CCO #42 Review Comments
By
Sandy Michelotti & Michael Travis
March 21, 2008

SAS SUPERSTRUCTURE ROADWAY WESTBOUND
LIGHTING AND ELECTRICAL SYSTEMS

E-46

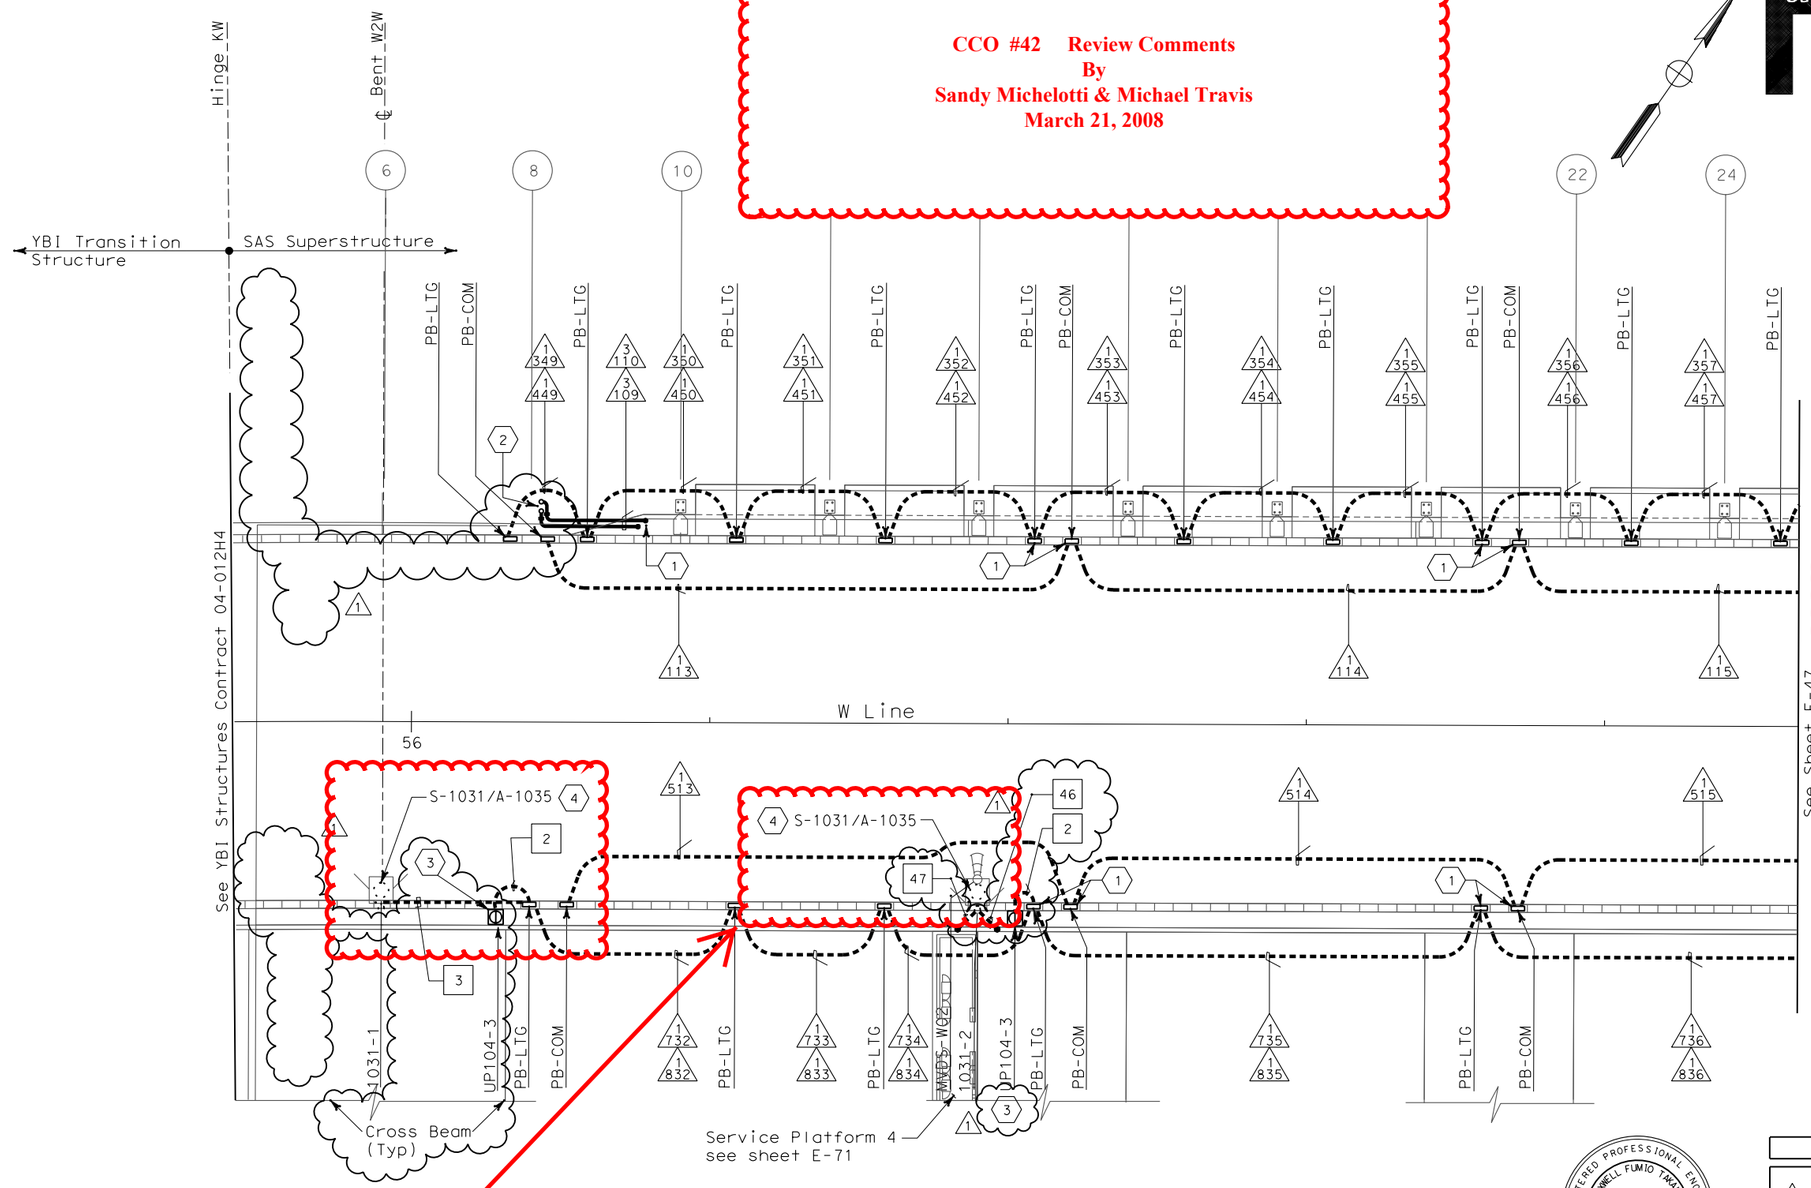
1. The removal of the light poles are not in this CCO.
   Remove all references to state furnished poles and detailing showing the poles are by others.
   The removal of the poles will take place in CCO #43.

E-49

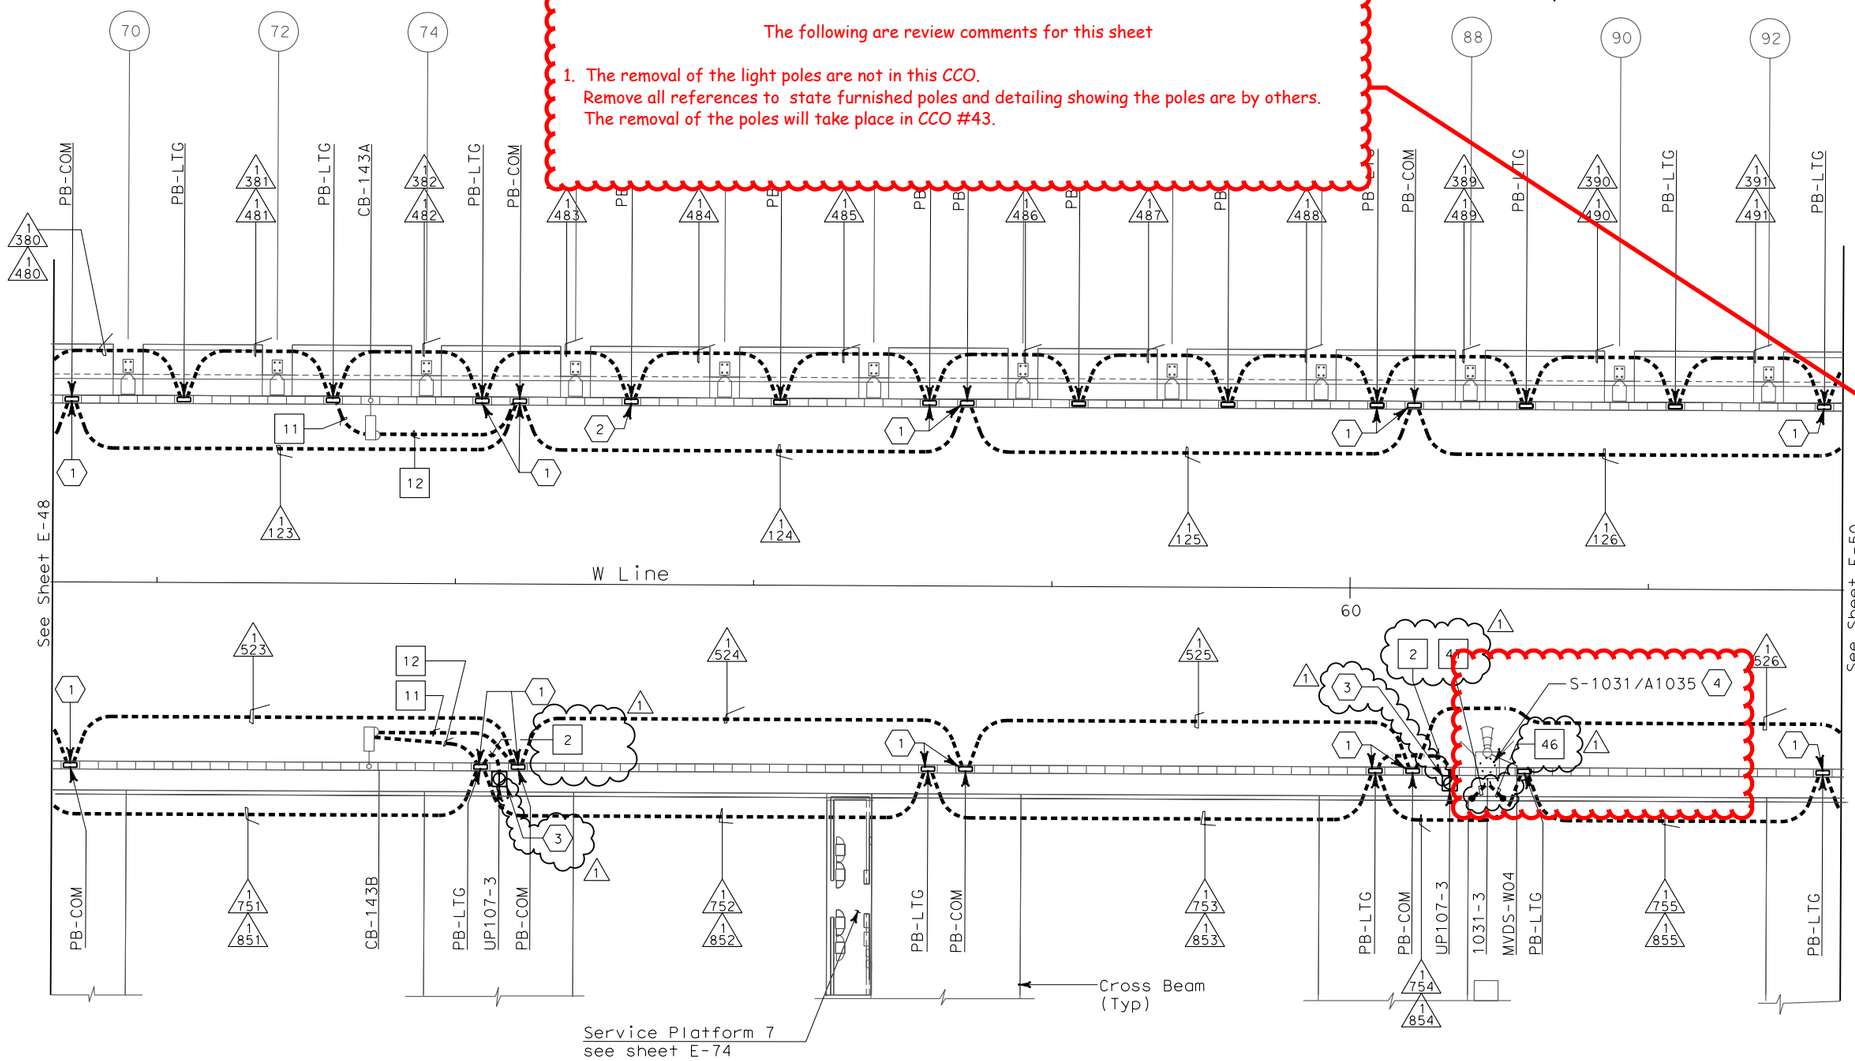
1. The removal of the light poles are not in this CCO.
   Remove all references to state furnished poles and detailing showing the poles are by others.
   The removal of the poles will take place in CCO #43.

CONDUIT PLAN

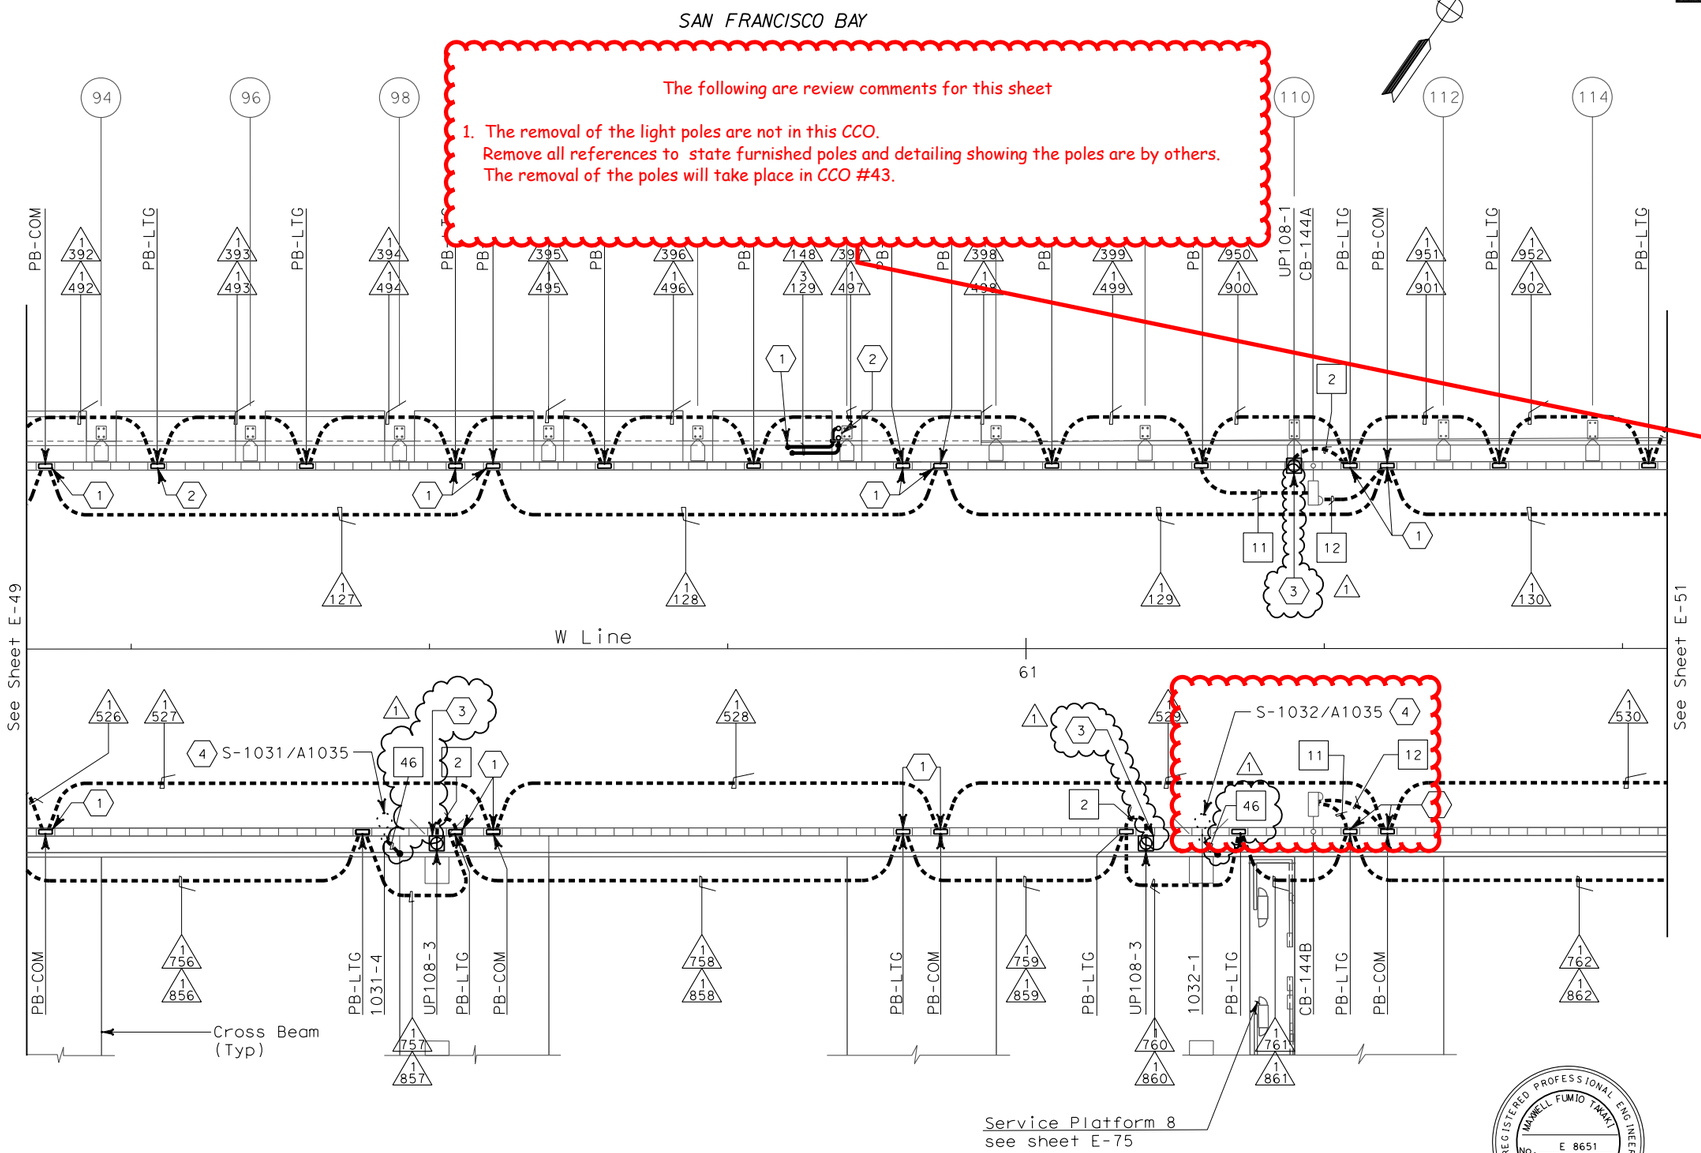
1. The removal of the light poles are not in this CCO.
   Remove all references to state furnished poles and detailing showing the poles are by others.
   The removal of the poles will take place in CCO #43.

CONDUIT PLAN

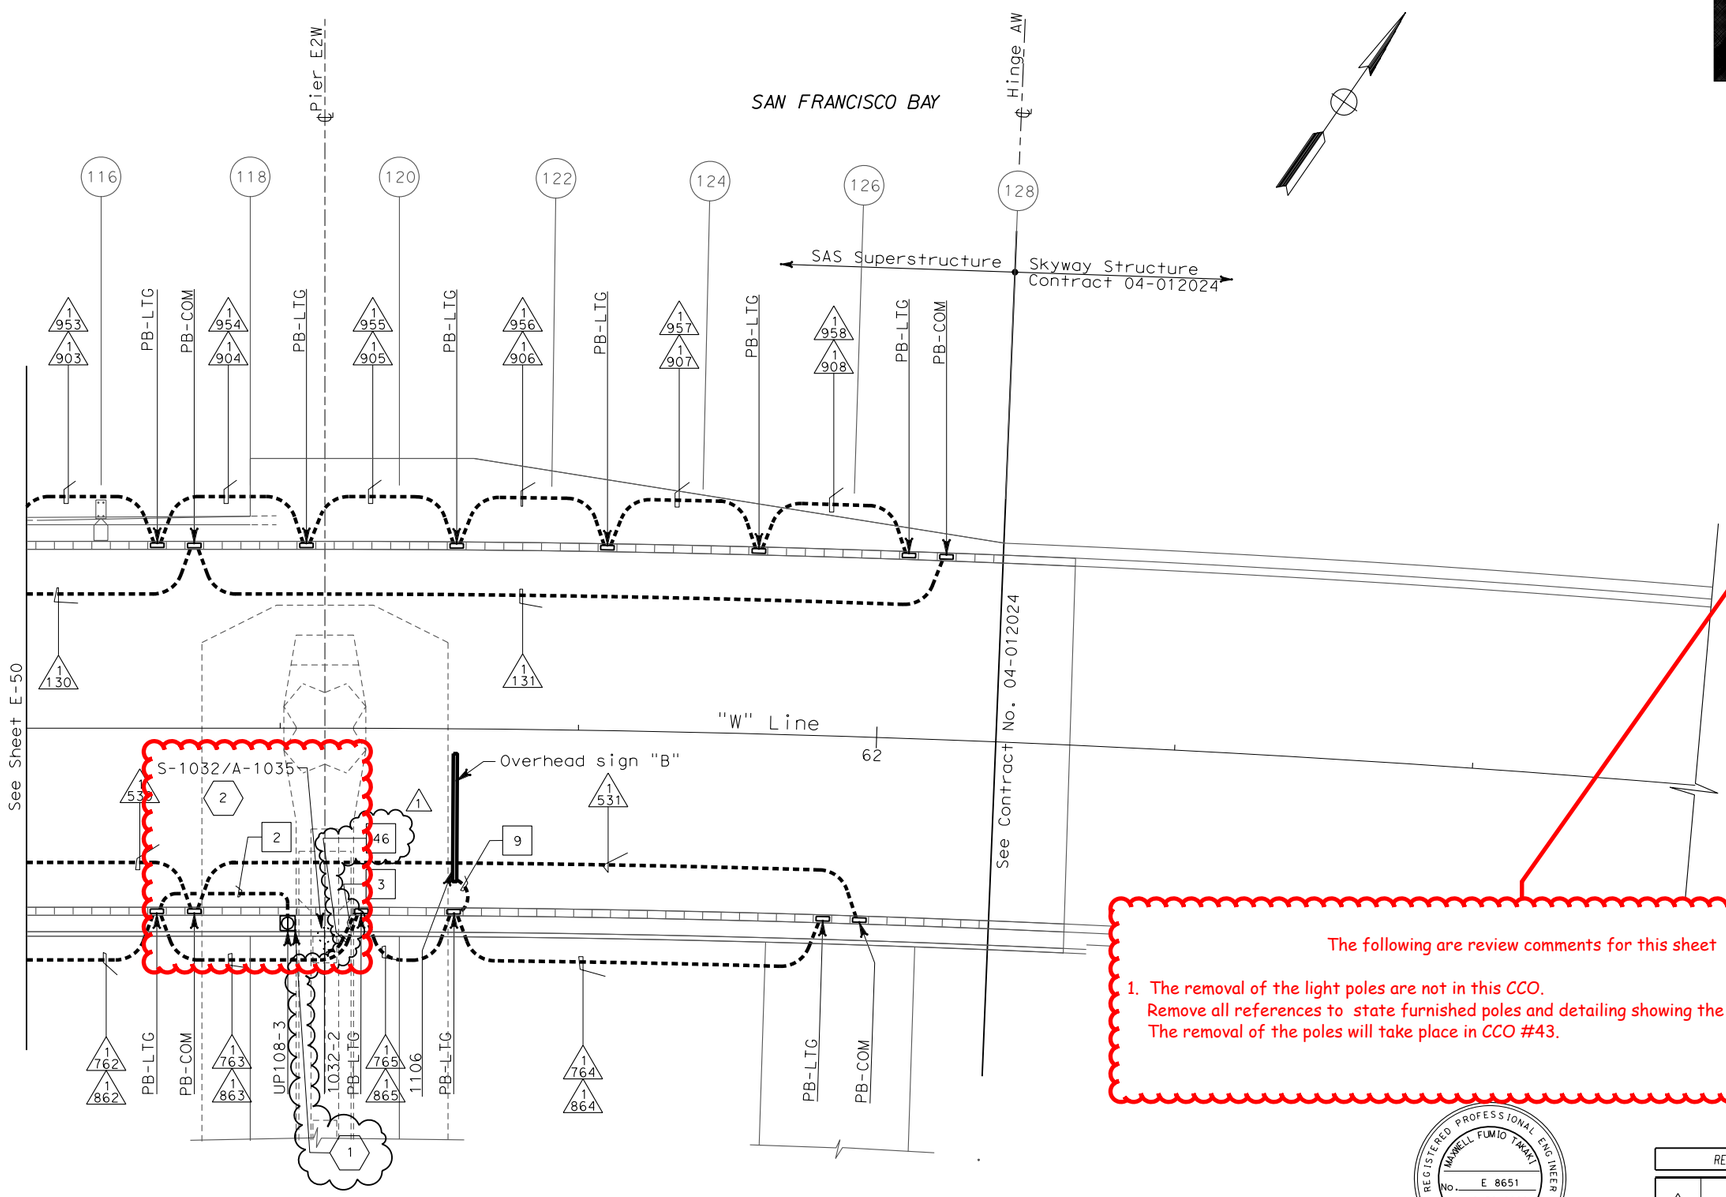
1. The removal of the light poles are not in this CCO.
   Remove all references to state furnished poles and detailing showing the poles are by others.
   The removal of the poles will take place in CCO #43.

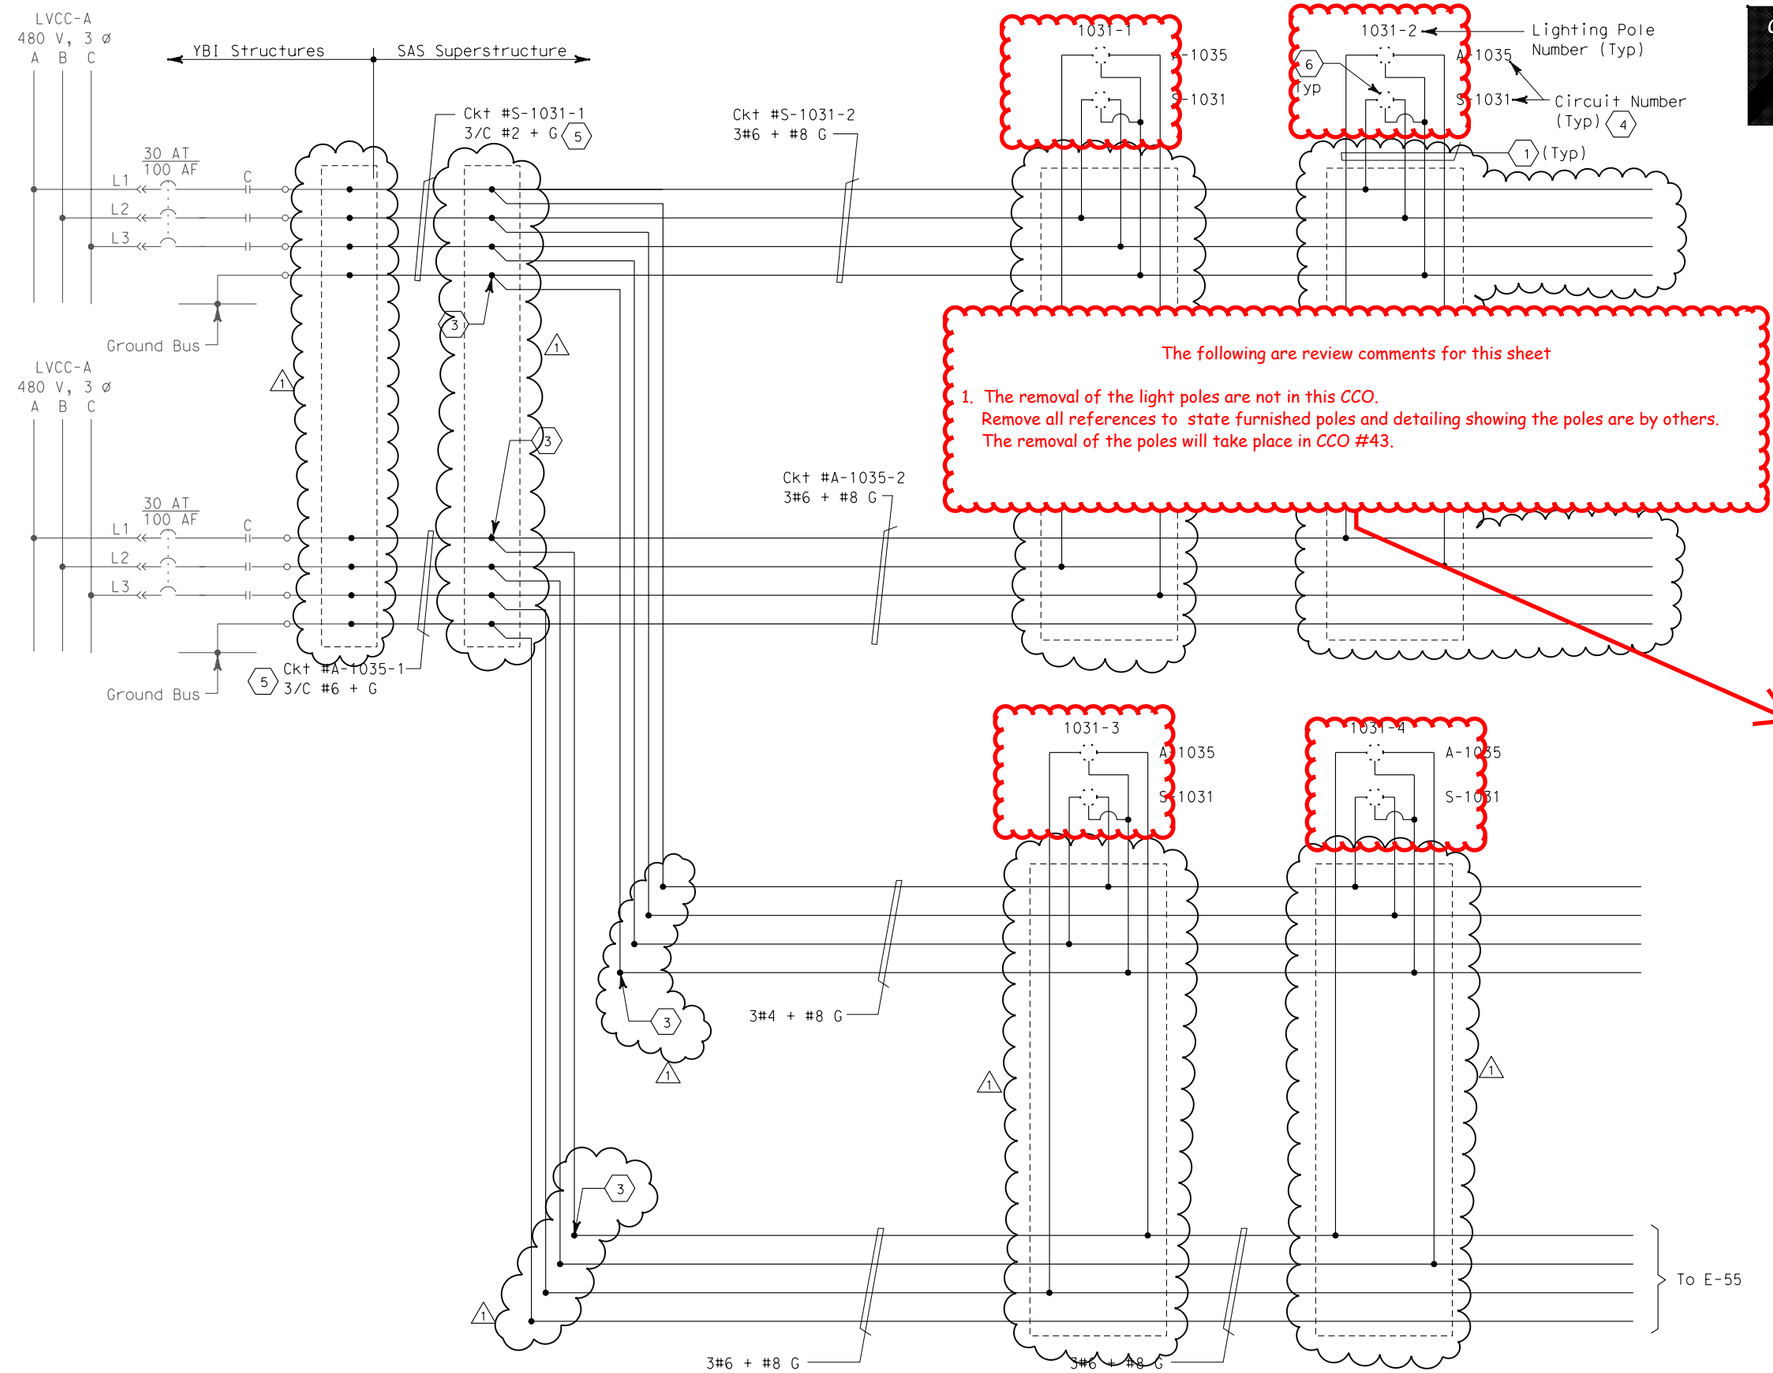
1. The removal of the light poles are not in this CCO.
   Remove all references to state furnished poles and detailing showing the poles are by others.
   The removal of the poles will take place in CCO #43.
